Pathways for Decarbonizing Transport towards Carbon Neutrality in China

Review CEO Endorsement and Make a recommendation

10790

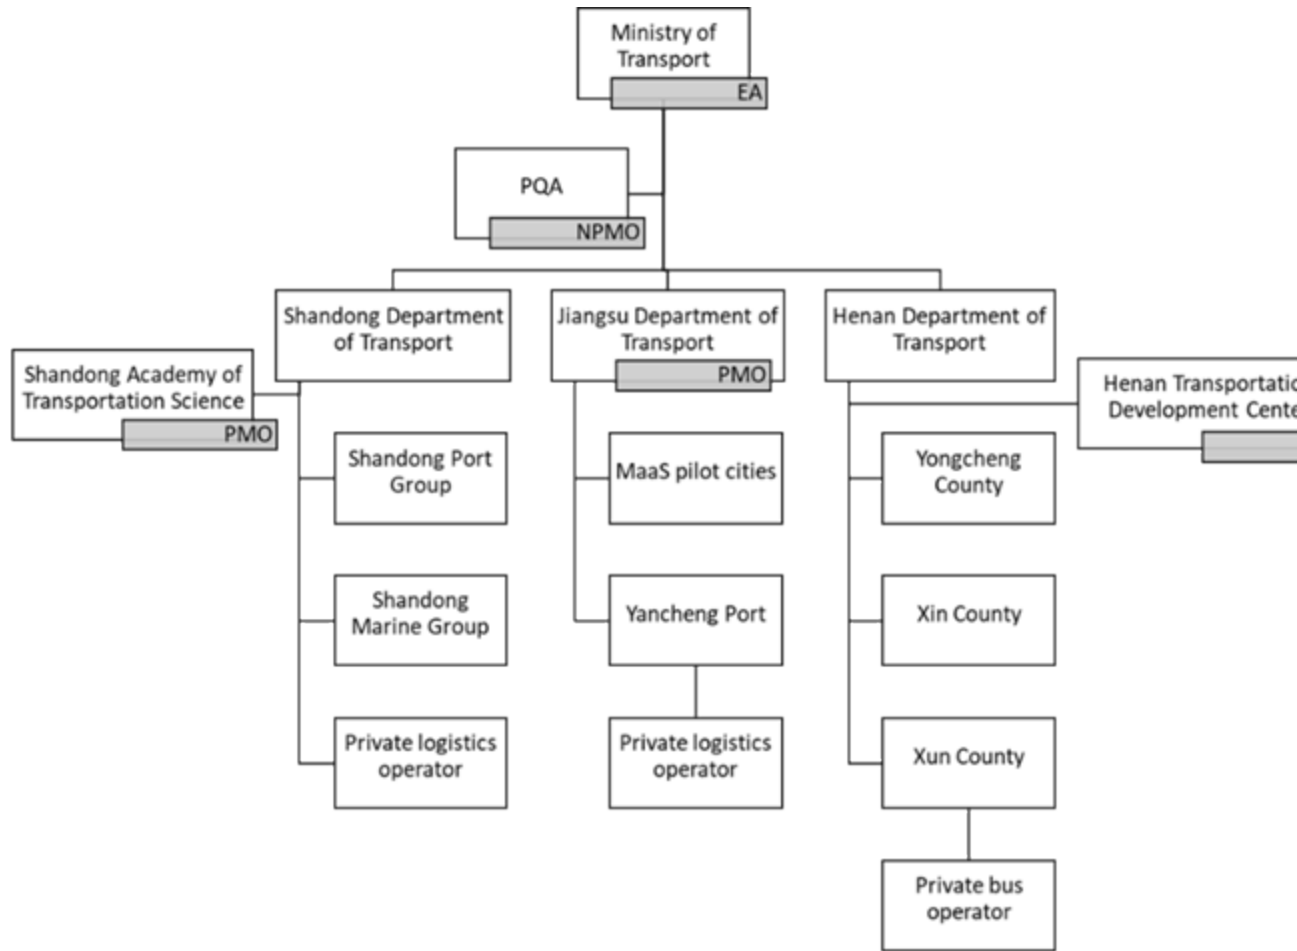
1. In the stakeholder engagement chart, please add the MOF which is the project owner and driver. The project should comply with the policy requirement of the MOF in terms of budget and outputs. The MOF has clearly provided the guidance on this issue in the four-party meeting on July 29, 2022. For example, the MOF indicated that the total budget for component 3 knowledge management, learning, and capacity building should be no more than \$240,000, and study tours should not be in the project. Such guidance will make this project compatible with other MOF financed projects in China.
2. Please add the names of the promising private companies in the chart.
3. Please put the revised chart in the PAD and the CEO ER document.

We have added MOF as the project sponsor and this chart is included in the PAD and CEO ER document. We would like to clarify that this is an implementation arrangement chart instead of a stakeholder engagement chart. Project stakeholders are more extensive (as indicated in the SEP), including relevant decision-making authorities, industry associations, urban and rural residents, etc. We are in the process of collecting the

names of the prospective private companies and will add them in the footnote to the chart prior to WB Board approval.
